# HOSHIZAKI AMERICA, INC.

## SERVICE BULLETIN

**SB10-0003**

### **Subject: Magnetic contactor (Relay) 428393-01 no longer available**

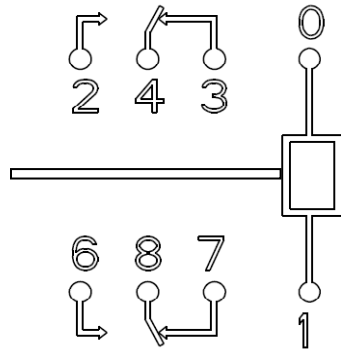
The manufacture of magnetic contactor (relay) 428393-01 has stopped production. This relay has been used for over twenty years on many Hoshizaki models. This relay is currently being replaced in production by the relays discussed below.

After service parts inventory is depleted this number will sub to two different part numbers. Relay-compressor 4A5096-01 will be used for remote models. Relay-compressor part number 4A3140-01 will be used for air cooled and water cooled models

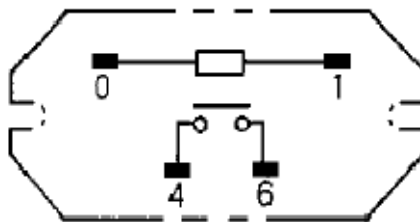
**Relay 4A3140-01** (For air and water cooled units) consist of one set of normally open contacts numbered 6 and 4. The NO contacts will be used for the compressor circuit. (See Below for relay schematic). Coil voltage will be supplied to terminals 1 and 0.

(Typical air cooled and water cooled wiring)

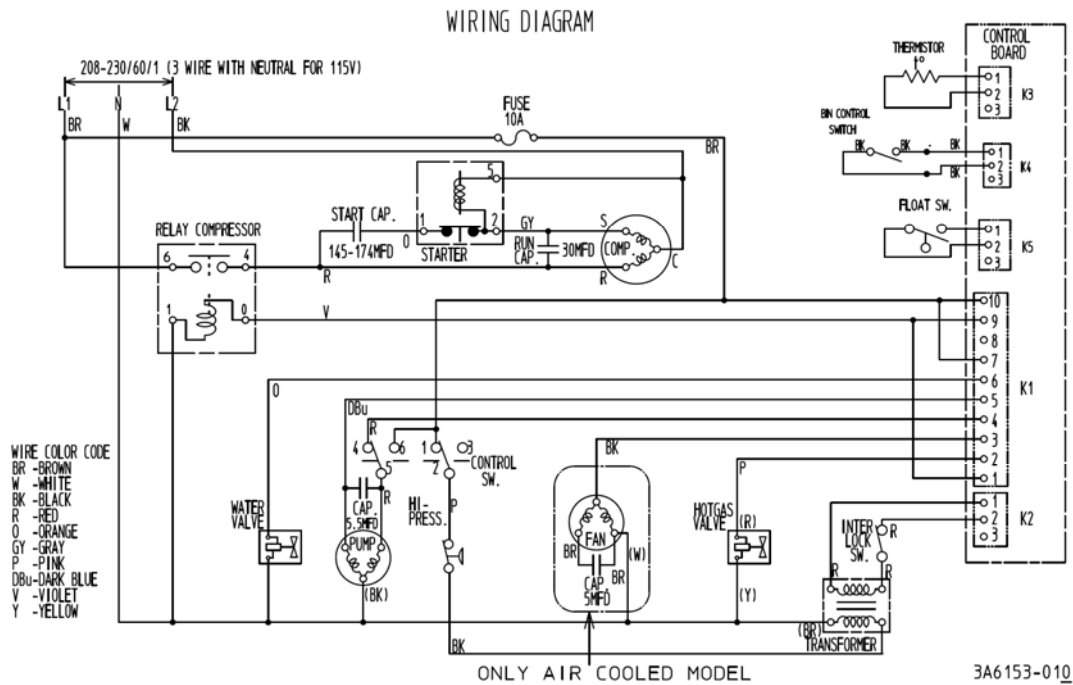
8. Mount new contactor.
9. Replace wiring as needed, referring to the attached generic diagrams for new numbering sequence.
10. Re-install control box cover.

(Typical remote wiring)

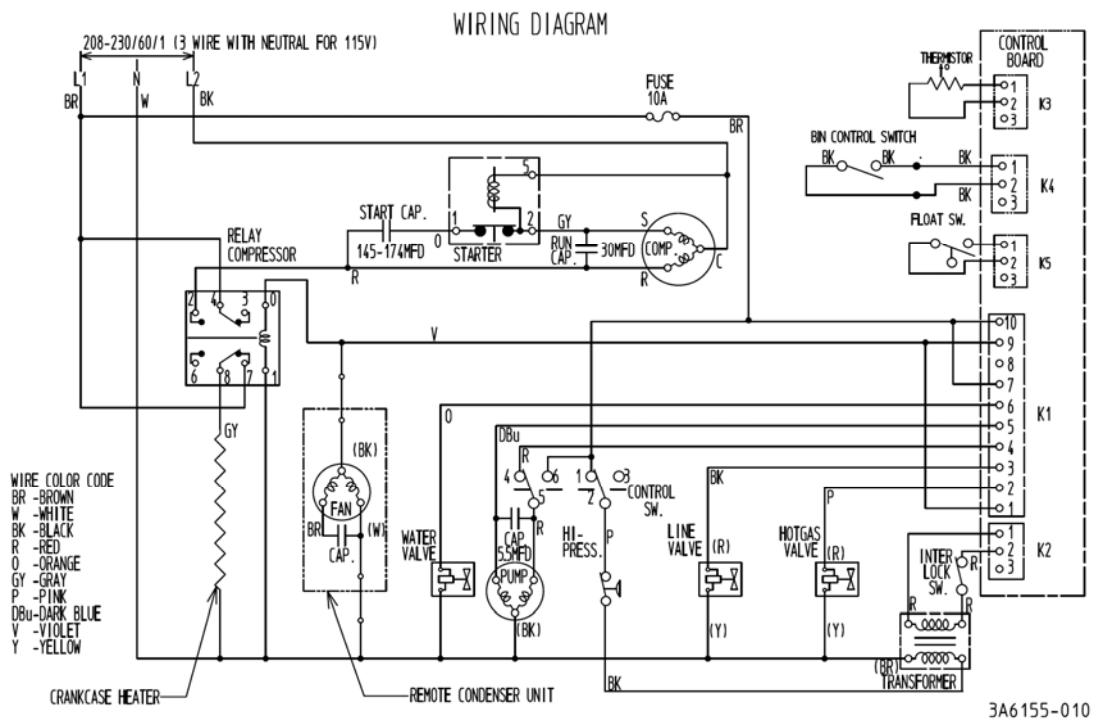
In typical remote applications the compressor circuit will be connected to one set of on the NO contacts (ex. 2 & 4) and the crankcase heater will be connected to one set of NC contacts (ex. 8 & 7). Coil voltage will be supplied to terminals 1 and 0.
